**Cambridge  
Crossing**

| Parcel H

OFFICE BUILDING - DESIGN REVIEW REVISION

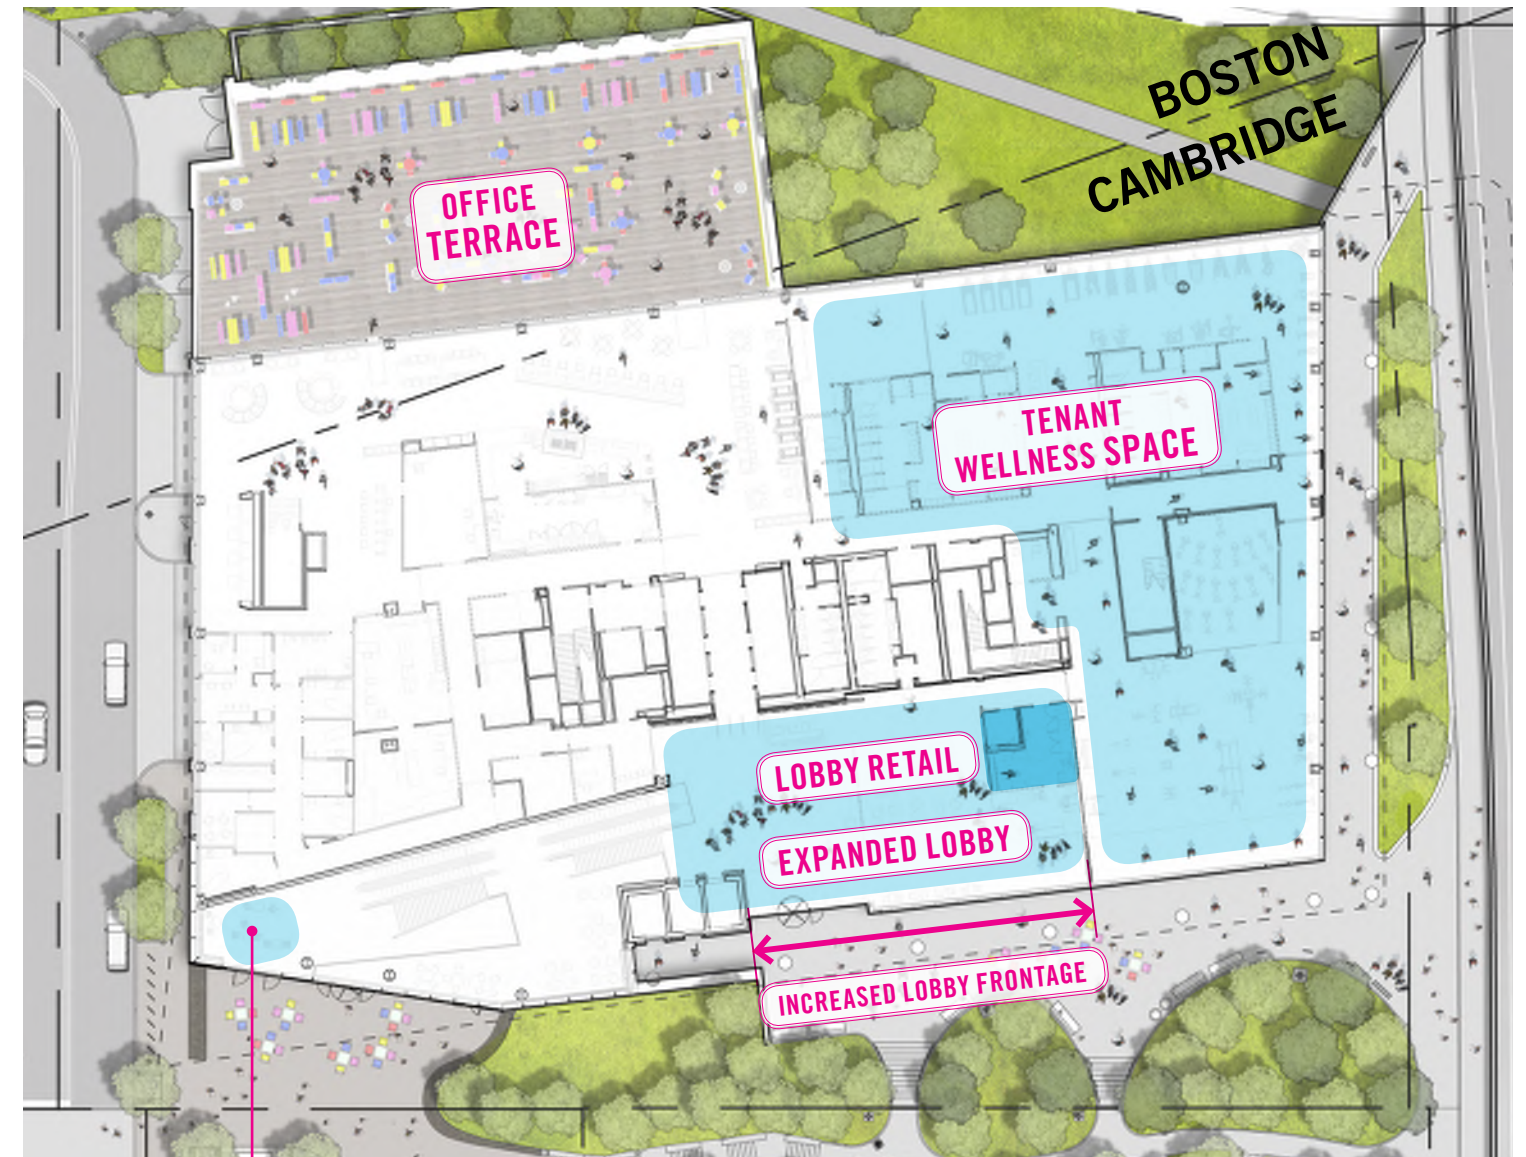
## DESIGN REVIEW REVISIONS LIMITED TO:

- Expanded Lobby
- Added Lobby Retail

EXISTING RETAIL at GROUND FLOOR

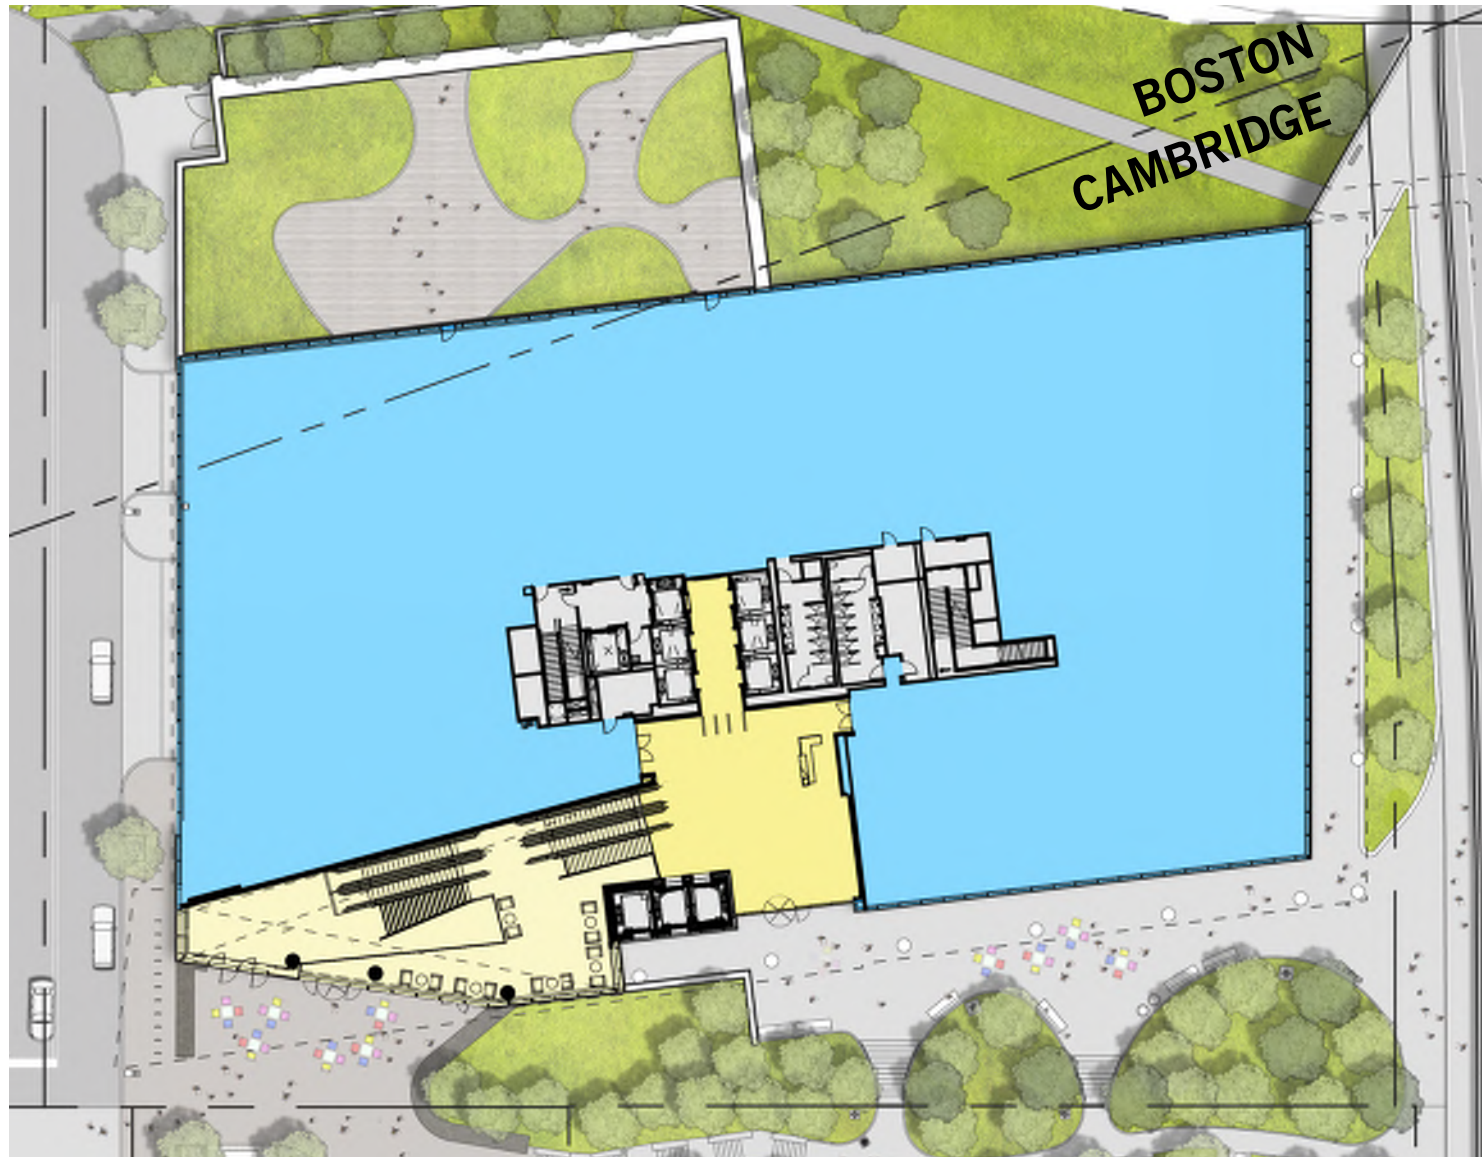
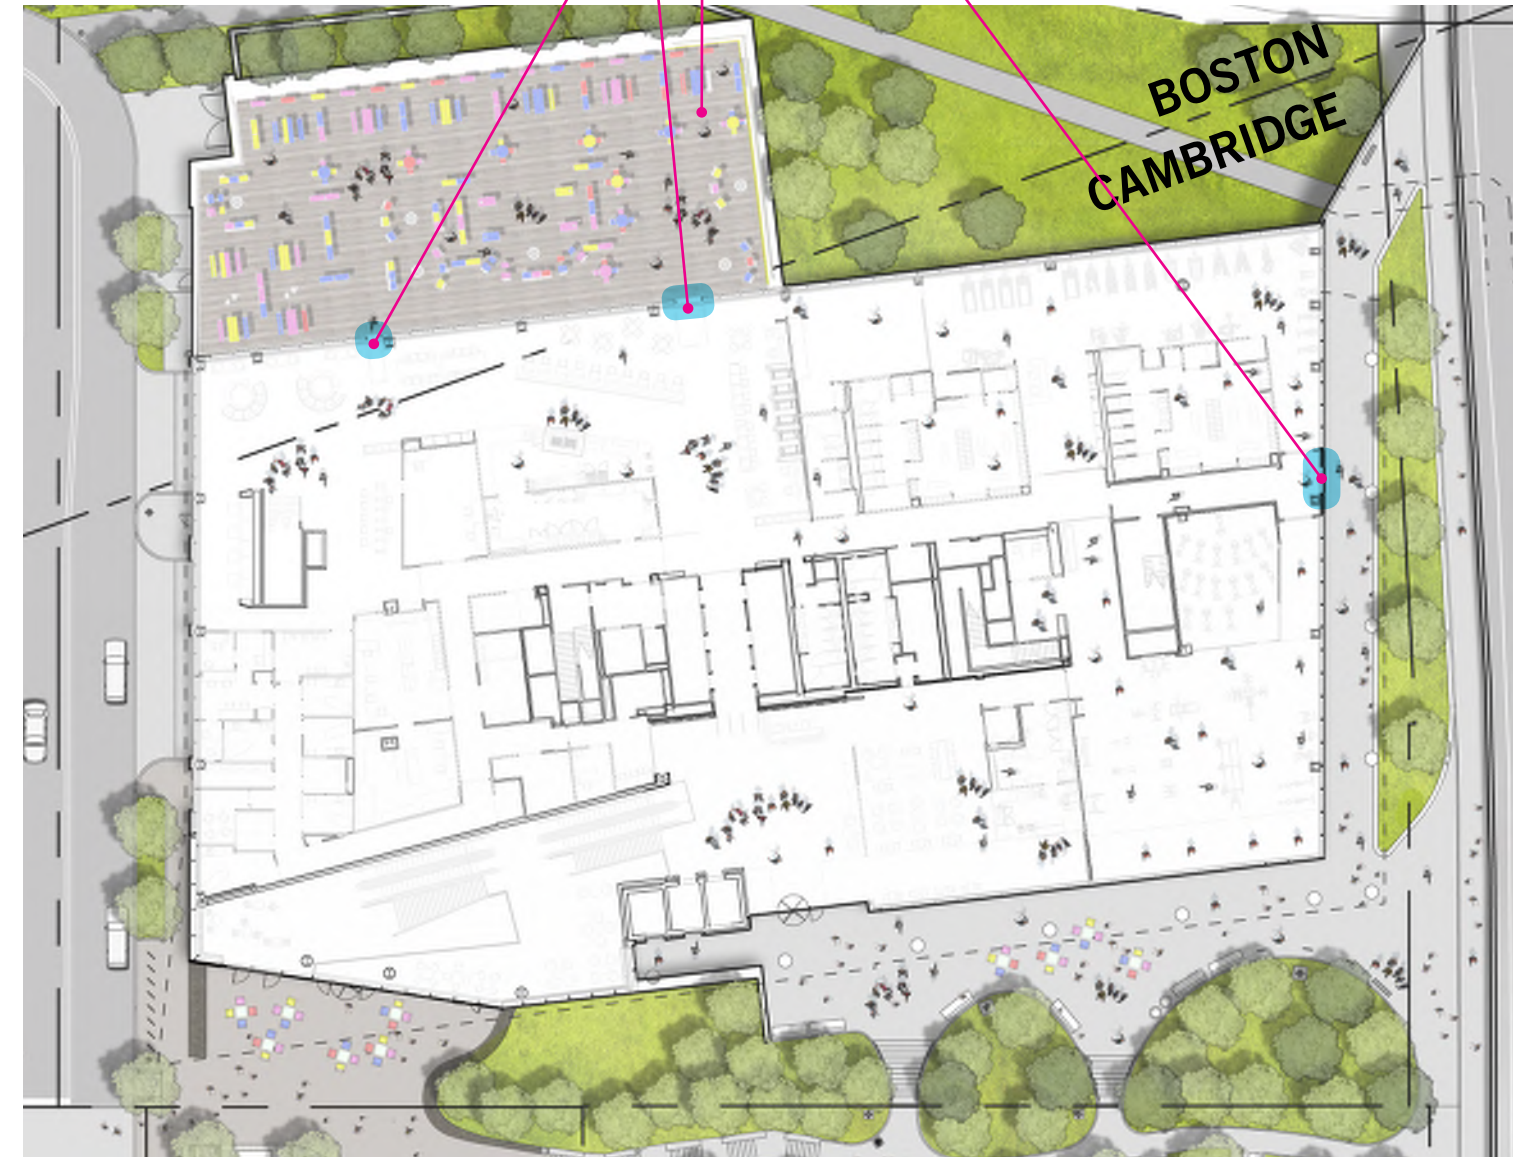
### DESIGN REVIEW REVISIONS LIMITED TO:

- Relocated Office Terrace Doors
- Added Exterior Door at Gilmore Bridge
- Finish tenant terrace

ADDED EXTERIOR DOOR AT GILMORE BRIDGE

FINISHED TENANT TERRACE

RELOCATED TENANT TERRACE DOORS

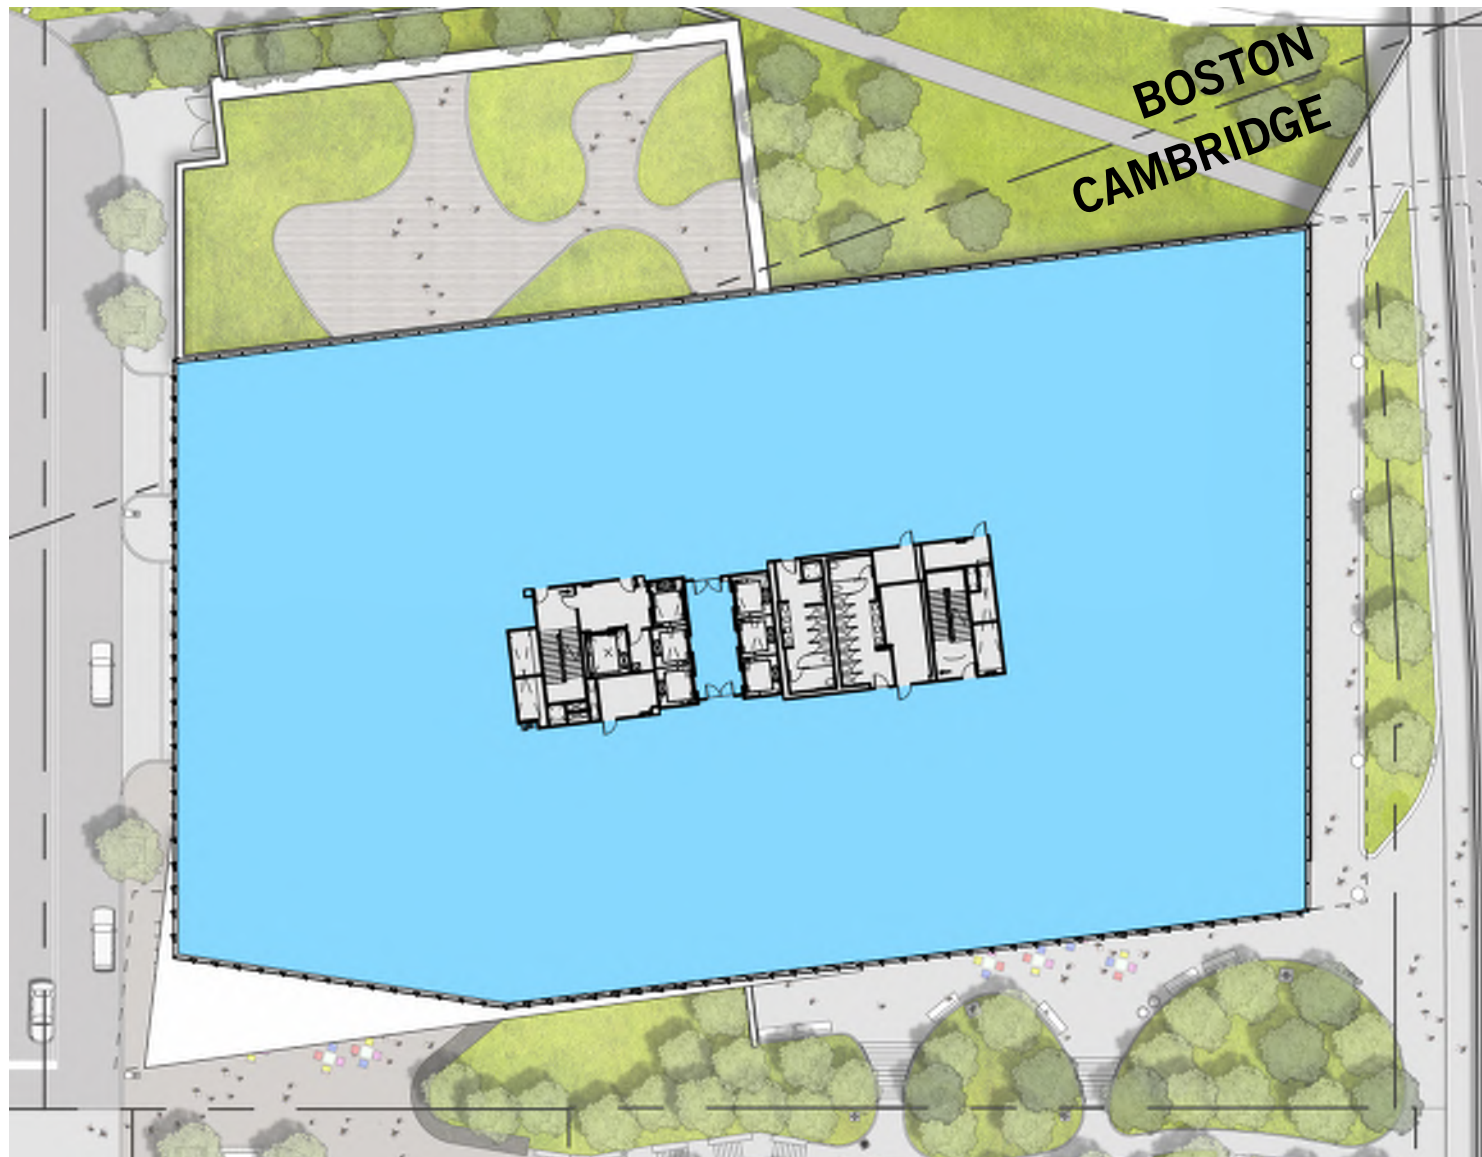
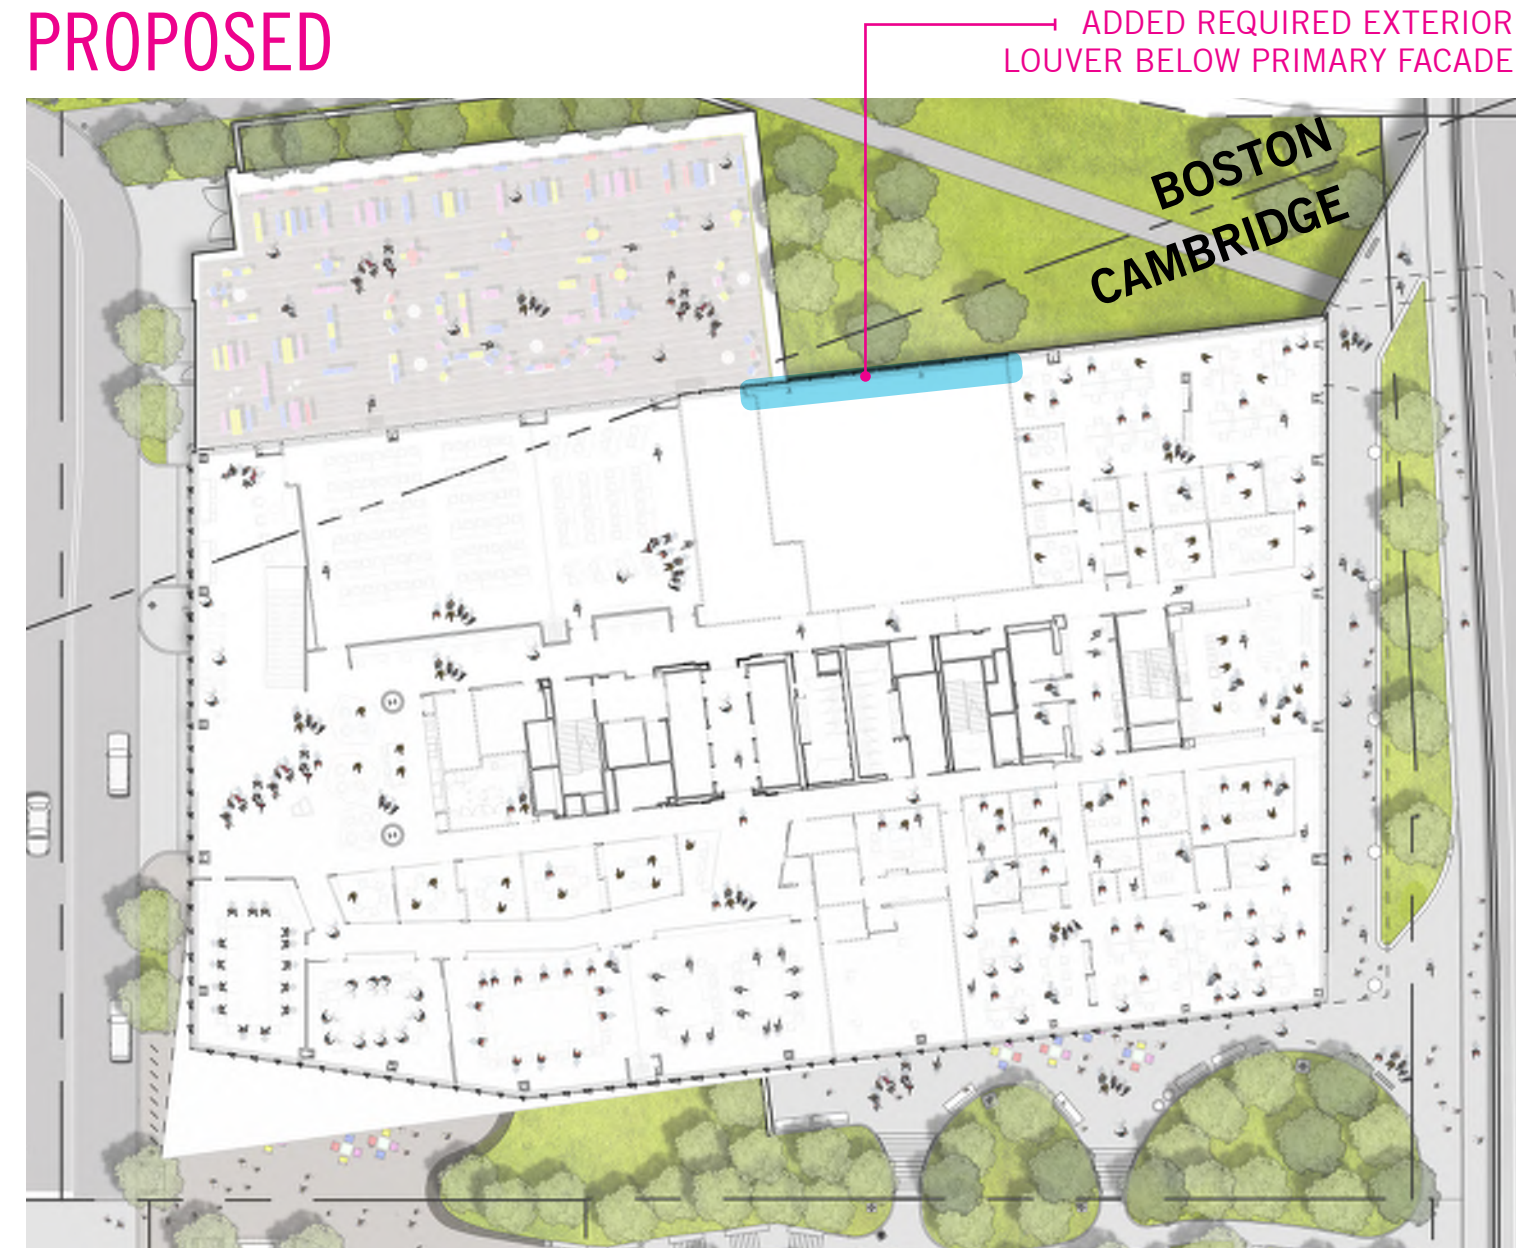
### DESIGN REVIEW REVISIONS LIMITED TO:

- Added Mechanicals on 3rd Floor Instead of on Roof
- Added Required Exterior Louver Below Primary Facade
